**WRITTEN STATEMENT: CONDITIONAL USE PERMIT (CUP)
FOR LETURNO-HWY 126**

AGENCY FILE NO.: PC 23 27 CUP 04
AGENCY CONTACT: WENDY FARLEYCAMPBELL, AICP,
COMMUNITY DEVELOPMENT DIRECTOR
CITY OF FLORENCE
WENDY.FARLEYCAMPBELL@CI.FLORENCE.OR.US

DATE OF THIS DOCUMENT: 01/12/2024

Figure 3 - Average Square Footage (SF) for Lots 10-03

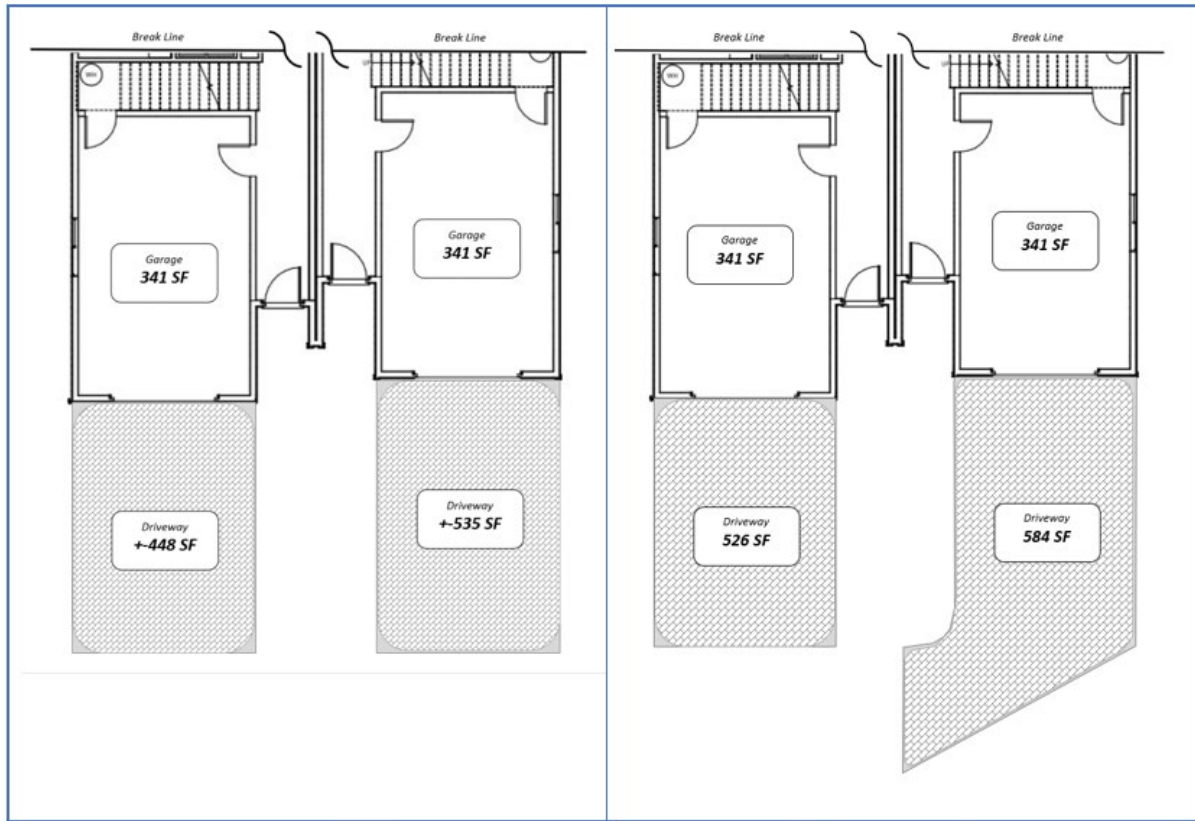
***Please provide width and length dimensions for each garage and driveway so that minimum requirements for parking can meet review.***

Response: Each resident will have sufficient parking for (2) vehicles and when commercial areas are developed shared parking will be provided as needed. Please see the figure of residential parking spaces illustrated below (and above on previous pages).
